Historic Landmarks and Preservation Districts Commission

Report to the Committee

Case No: 18COA1115
Classification: Committee Review

Property Address: 608, 610, 612, 614, 616 W. Breckinridge Street

Figure 1. The 2/2 double hung vinyl window that was turned on its side and installed as a sliding window.

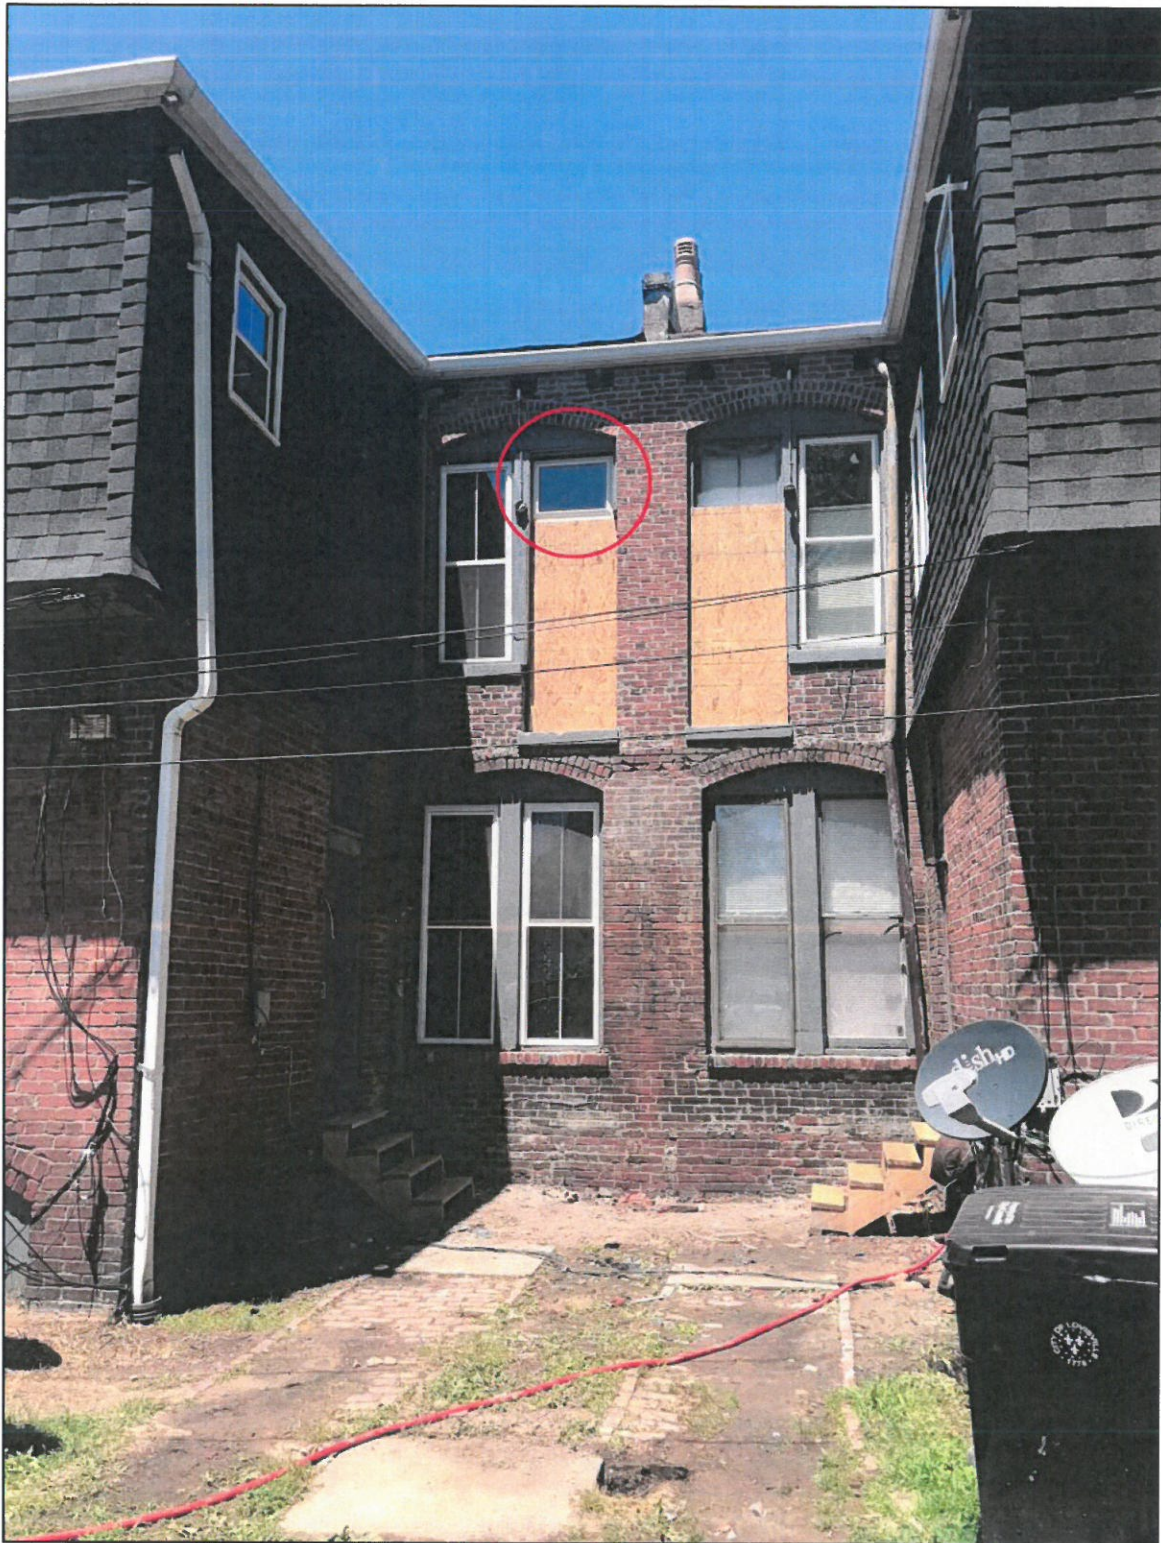
Sides and rear elevation windows: The proposed sides and rear elevation window replacement generally meets the Limerick Design Guidelines for **Window**. Even though most of the replacement occurred before the window conditions could be assessed, the replacement windows mimic the historic 2/2 double hung windows and fit the historic window openings. However, there is one replacement window on the east elevation of the rear that staff recommends replacement. It appears that one 2/2 double hung vinyl window was turned on its side and installed as a sliding window (**Figure 1**). This is not appropriate as it

does not meet the design guidelines with its horizontal muntins. The window should be replaced with a new sliding window with no muntins. Some of the rear window concrete and/or limestone sills had been replaced with brick window sills. Staff recommends that the remaining concrete and/or limestone sills on the rear elevation be preserved. They should not be replaced with brick sills as this is not an appropriate sill treatment on a historic structure.

1. All replacement windows shall fit the historic window openings by matching the shape and size of the historic windows.
2. The replacement transom windows shall match the size and shape of the historic transom windows and have one central, vertical muntin making them two-lite windows.
3. The already installed replacement transom window shall be replaced to meet condition 2.
4. The 2/2 double hung vinyl window that was turned on its side and installed as a sliding window (east elevation) shall be replaced with a new sliding window with no muntins.
5. The remaining concrete and/or limestone sills on the rear elevation shall be preserved. They shall not be replaced with brick sills.
6. If the design or materials change, the applicant shall contact staff for review and approval.

Figure 4. The new 2/2 double hung vinyl windows over 608 W. Breckinridge Street.

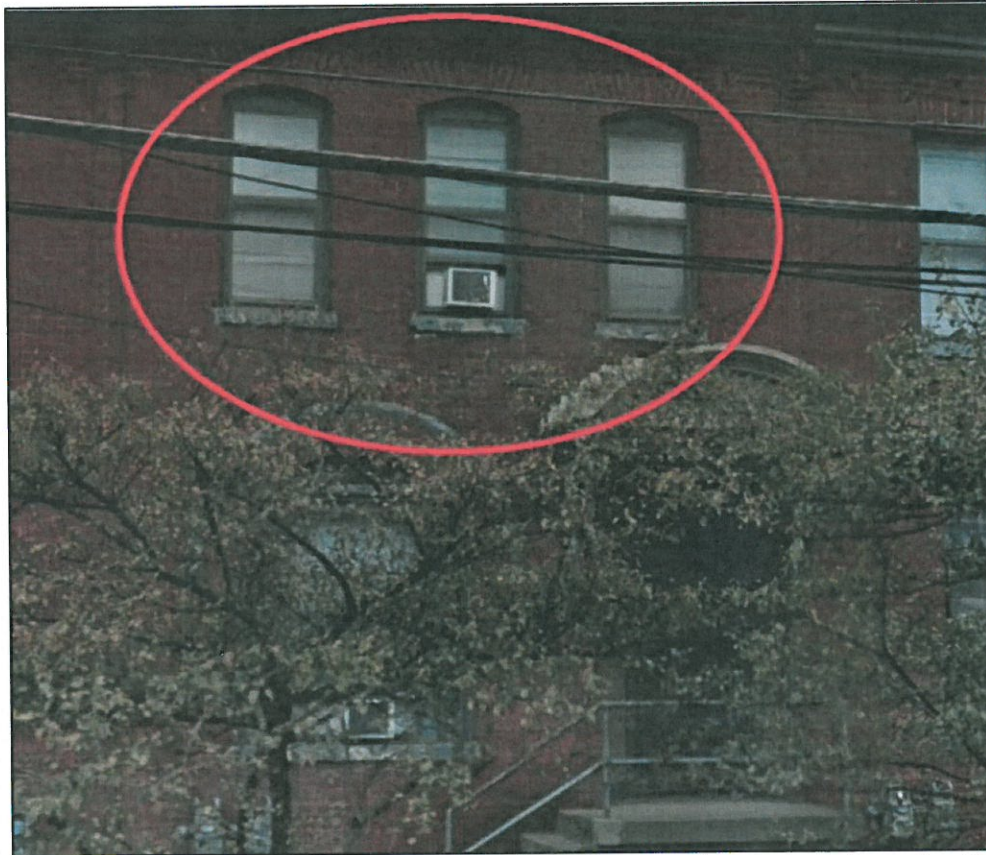
Front façade windows: See **Figure 3** for a key of the windows discussed below. The windows that were replaced prior to the stop work order include numbers 1, 2, 3, 4, 9, 10, 11, 12, 15, and 16. The proposed front façade window replacement does not meet the Limerick Design Guidelines for **Window**. The historic windows on the front façade were a mix of rectangular and arched double hung windows. All of the windows were 1/1 meaning they had no muntins. Historically, solid sheets of glass for 1/1 windows were more expensive than the smaller panes for multi-pane windows, which is why 1/1 windows were located on the front façade and multi-pane windows were located on the side and rear elevations. The replacement windows on the front façade are all 2/2 double hung vinyl windows, which do not match the historic windows or meet Guideline W2 or W6. The replacement windows are somewhat tinted and reflective, which does not meet Guideline W10. The second story replacement windows over 608 W. Breckinridge Street (Windows 1 and 2) do not fit the arched window openings creating large gaps (**Figure 4**). Furthermore, the wood that filled the segmented arched windows over 612 W. Breckinridge Street (Windows 9, 10, and 11) allowed a rectangular window to fit under an arched opening, but that wood was removed and a vinyl window was inserted that does not fit (**Figure 5** and **Figure 6**). These fit issues do not meet Guideline W4.

On the basis of the information furnished by the applicant, staff recommends the application for a Certificate of Appropriateness for front façade window replacement be **denied**.
